Certificate of Substantial Completion

PROJECT: <i>(Name and address)</i> 10020-Valley View Fire Station No. 1 1273 Stump Bridge Road Canton, MS 39046	PROJECT NUMBER: 10020/ CONTRACT FOR: General Construction CONTRACT DATE: September 20, 2012	OWNER: <input type="checkbox"/> ARCHITECT: <input type="checkbox"/> CONTRACTOR: <input type="checkbox"/> FIELD: <input type="checkbox"/> OTHER: <input type="checkbox"/>
TO OWNER: <i>(Name and address)</i> Madison County Board of Supervisors PO Box 404 Canton, Mississippi	TO CONTRACTOR: <i>(Name and address)</i> Richard Womack Construction, LLC 141 Blackwell Road Mendenhall, MS 39117

FIELD OBSERVATION REPORT

FIELD OBSERVATION REPORT

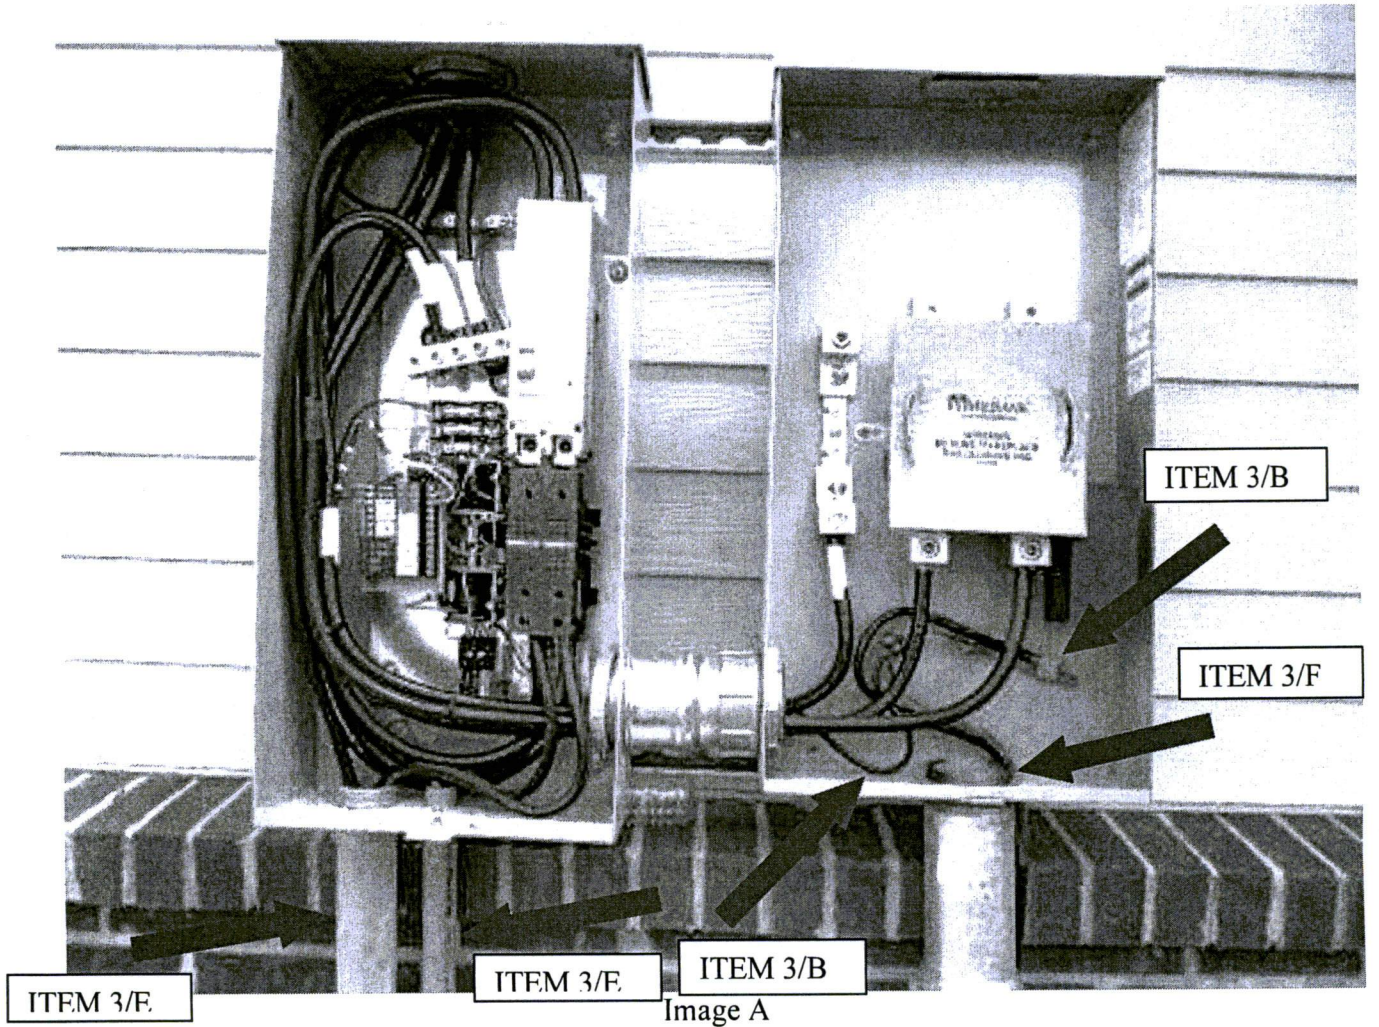
2. Smoke Detectors: The detectors were installed but could not be properly checked without utility power.
3. Power Distribution System: The panels are completed. Utility power has not been connected. The following was noted as incomplete or requiring correction; See image A.

- A. Complete grounding to water, gas and building steel per detail 2/E0.1.
 - B. Use split bolt (or other conductor termination unit) connection for grounds in meter base. Pig tail from this connection to housing bond. Replace # 4 ground conductor with # 2 conductor to the service entrance ground bar in the transfer switch.

- E. Generator conduits exposed to weather and abrasion are PVC, specification 16110 1.2 B & C requires conduits exposed to weather to be GRS type conduit. Bushing are not installed on conduits.

- F. Install grounding bushing on service feeder conduit. Coat GRS conduit treads with cold Zinc galvanizing.
 - G. Detail 2/E0.1 requires three ground rods be installed in a triangle form. The Contractor has installed two ground rods in a straight line. The Contractor shall test the grounding per specification 16010 3.11 B.
